WEST ERREGULLA PROCESSING PLANT AND PIPELINE

Response to Submissions

EPA Assessment No. 2305

Revision 2

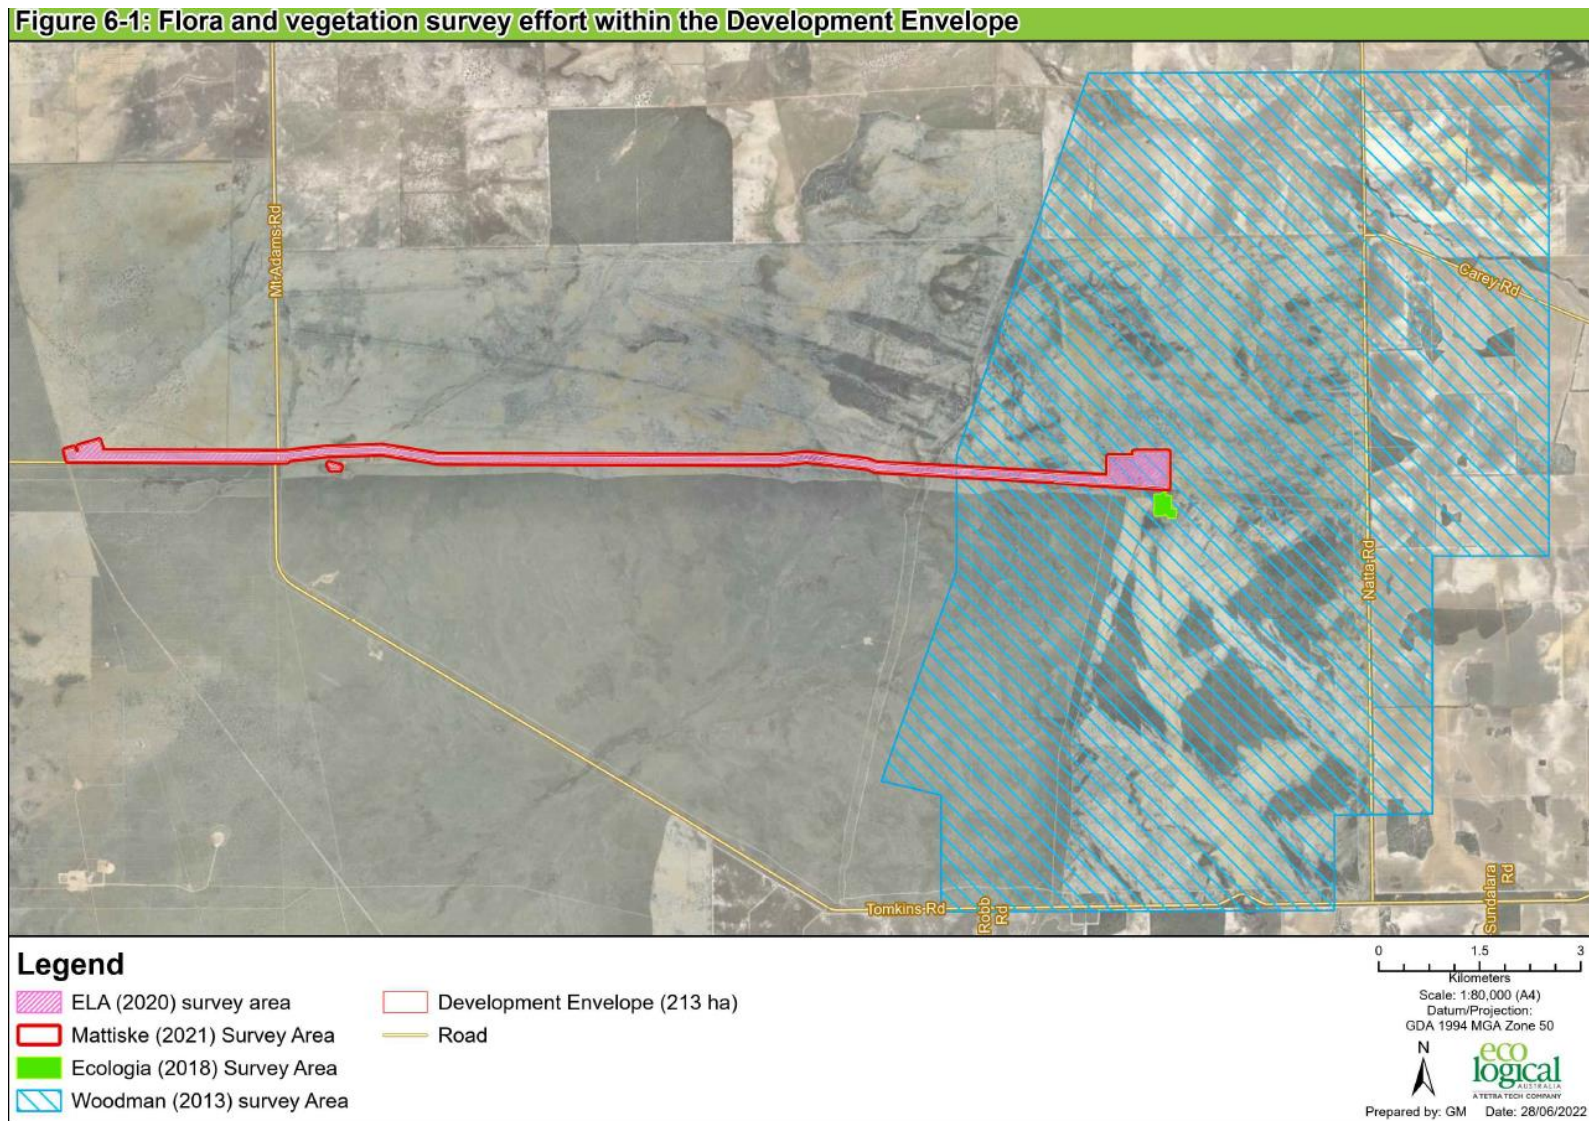
Item	Submitter	Comment / Query	Response	Document Reference
		<ul style="list-style-type: none"> Figure 6-1 needs to include the Ecologia (2018) and Matiske (2021) survey areas. Figure 6-3 needs georeferencing. Figure 6-3 needs the missing map (page three of three pages). Figure 6-4 needs species names in the legend. Outcome of all significant flora studies (i.e. combine Figures 6-3 and 6-4). 	<ul style="list-style-type: none"> Figure 6-1 Figure 6-4 <p>Figure 6-3 is georeferenced. The map was created within a Geographical Information System and all data shown within the map has been appropriately georeferenced.</p> <p>All three pages of Figure 6-3 are included at Appendix A of this document.</p> <p>Figure 6-4 shows the outcome of all significant flora studies.</p>	Section 6 of this RtS
10	DWER	The ERD has adequately described impacts to vegetation. Eco Logical Australia (2021) described six vegetation communities within the development envelope that correspond to five Woodman Environmental Consulting (2013) vegetation types (VTs). However, the direct impacts to the local vegetation communities are not substantial (Table 6-11).	Noted.	ERD – Section 6.5

9	DWER	To inform the assessment, maps incorporating the following changes should be provided:	The following maps have been updated as requested:	Updated ERD Mapping in
